North Harbour 2 Watermain - Earthworks, Erosion and Sediment Generation for Albany Reservoir Option 2

Project Name: North Harbour 2 Watermain
Project Number: AE04521

Additional information relating to NH2 and NI Shared Corridor - Options 1 & 2 at Albany Reservoir, Spencer Ridge Reserve and Corinthian Drive

Re: NH2 Option 2 Albany Reservoir – updated drawing no. 2010673.532

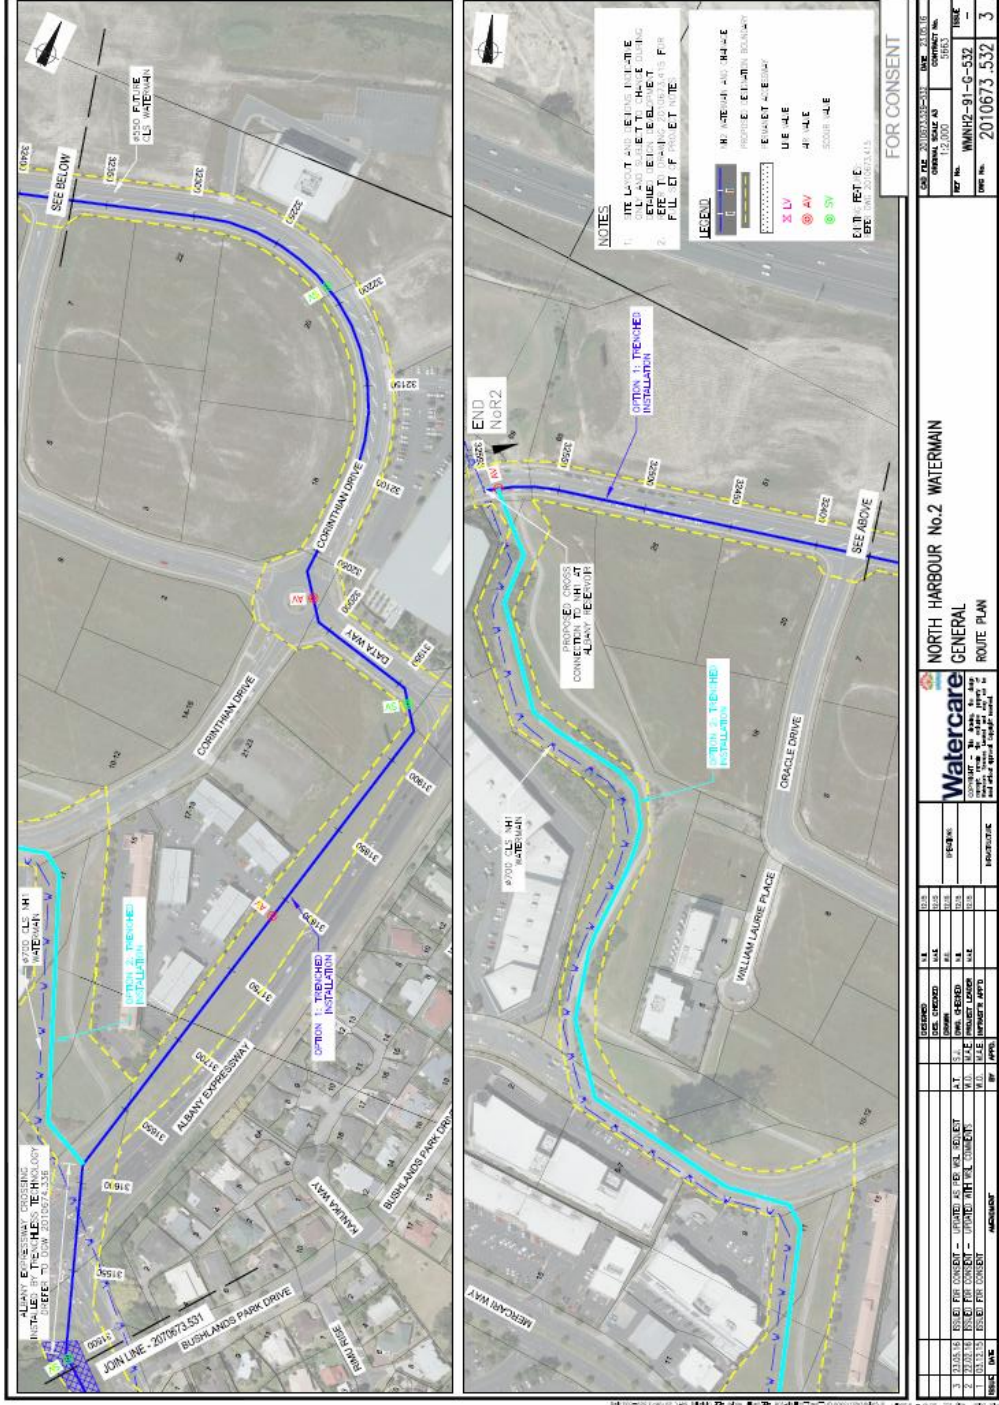
Section 8, 9, 10 and 11 are also applicable to the mitigation of route Option 2. Option 2 will not cross any overland flow paths or streams, or flood plains (as shown in the Auckland Council GIS Catchments and Hydrology layer). There will be no additional effects or mitigation required for this section of open trench.

This letter confirms that I have assessed the designation boundary around Option 2 (light blue) and that I have nothing to add to my Technical Report B – Soil and Groundwater Contamination Assessment- Final, dated 18 April 2016. The reasons for this are as follows:

This letter highlights the AEE related to groundwater for Option 2, at the Albany reservoir, within the park (DWG 2010673.532). Using Option 2 for this trenched section will not result in any changes to the potential effects assessed for Option 1. This is because the two options occur within the same hydrogeological area for the purposes of this assessment. Consequently, potential drawdown due to open trench excavation is expected to be minimal away from the excavation face (e.g. <1m at 30m from the trench and tapering off to zero beyond this distance).

From a desktop assessment, it was determined that 'Option 2' runs through a few small patches of young native restoration plantings within Spencer Ridge Reserve. The ecological value associated with 'Option 2' are low. The ecological effects for 'Option 2' are expected to be minor with the potential loss of a small amount of young native vegetation.

The Option 2 alignment as shown in light blue on Drawing No 2010673.532 avoids Data Way entirely so there would be no need to close Data Way. A considerable percentage of the Option 2 alignment is in the reserve so it is expected that there would be less overall impact upon general traffic during construction. However, there would be traffic impacts along Corinthian Drive during the construction period in the vicinity of 5-9 Corinthian Way. This section of Corinthian Drive near the driveway to 9 Corinthian Drive is narrower than other sections of the road as there is no shoulder or on-street parking. Through appropriate traffic management, it is expected that Corinthian Drive could be kept open. The driveway in 9 Corinthian Drive will only be affected for 2 to 3 days and timing of the work will be done in consultation with the property owner and tenants immediately prior to construction to minimise disruption.

It should be noted that the section of road near 9 Corinthian Drive would likely be restricted to only 1 lane of traffic during construction. The current alignment of Option 2 would block the driveway to 9 Corinthian Drive during construction. To mitigate this effect, one of the following measures is recommended:

1. Option 2 alignment could be moved to the north side of the road as the current alignment would block the driveway during construction (see attached sketch).
2. Complete the construction work in the vicinity of 9 Corinthian Drive during off peak periods (i.e., nights, weekends or holidays) to minimise the impact

- This option is in a generally commercial area, with setbacks of at least 40 m between works and receivers.
- The management processes documented in section 3 of our Technical Report F dated 29 April 2016 that was included with the application, remain appropriate.
- The effects would be consistent with "typical works" as detailed in section 8.2 of Technical Report F.

It is considered that the option to go through the open space will not increase any of the adverse landscape and visual effects outlined in my assessment report. There may be some removal of vegetation required but the specimens are of a scale and age which can be readily replaced. There are no above ground structures proposed with the option so there will be no residual adverse visual effects. There will be some temporary visual effects during construction but these are considered less than minor.

Upon review of the report and plans it has been identified that the report has erroneously referenced the two proposed options, in relation to trees numbered 134, 135 and 136. The report should read that Option 1 is the preferred option from an arboricultural perspective and Option 2 would require replanting of the Spencer Ridge Reserve to replace trees that may need removal for the open trenching in that corridor (if chosen).

Thank you for sending through the updated drawing for the Albany Reservoir section of proposed works (as attached). I have reviewed the changes to the plan which comprise the addition of the designation boundary around the proposed Option 2 alignment at Albany Reservoir and can confirm that this alteration does not affect the existing assessment of this area. No further assessment is required.

Where practicable, construction activity should be adjusted to avoid or minimise disturbance to native vegetation. Where native vegetation loss does occur, at a minimum, this vegetation should be re-instated post construction using the same diversity of plants that were originally there.
